PLANNING + NEIGHBORHOOD SERVICES DEPARTMENT Urban Planning Division

RE: Letter Agreement for the 1415 N Tejon Covered Deck Addition

Pikes Peak Regional Building Department Plan No.: 188542

Exhibit "1" to Safigan Letter Agreement Site Plan

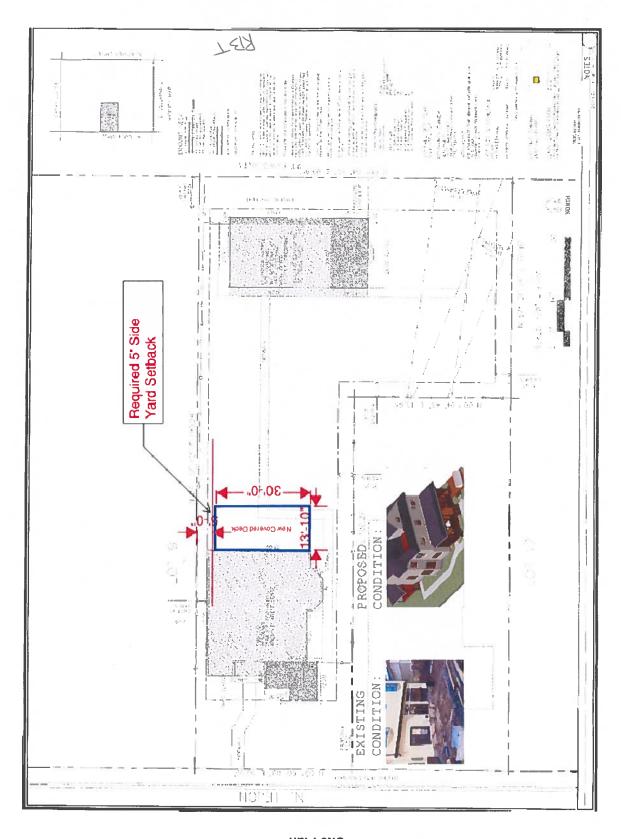
- 3. As of April 24, 2024, the plans associated with Plan #188542 show the covered deck addition setback three feet (3') from the lot's north property line. The plans need to be revised showing the covered deck addition having the five feet (5') setback required in the R-1 6000 zone district and as illustrated on "Exhibit 1" attached hereto.
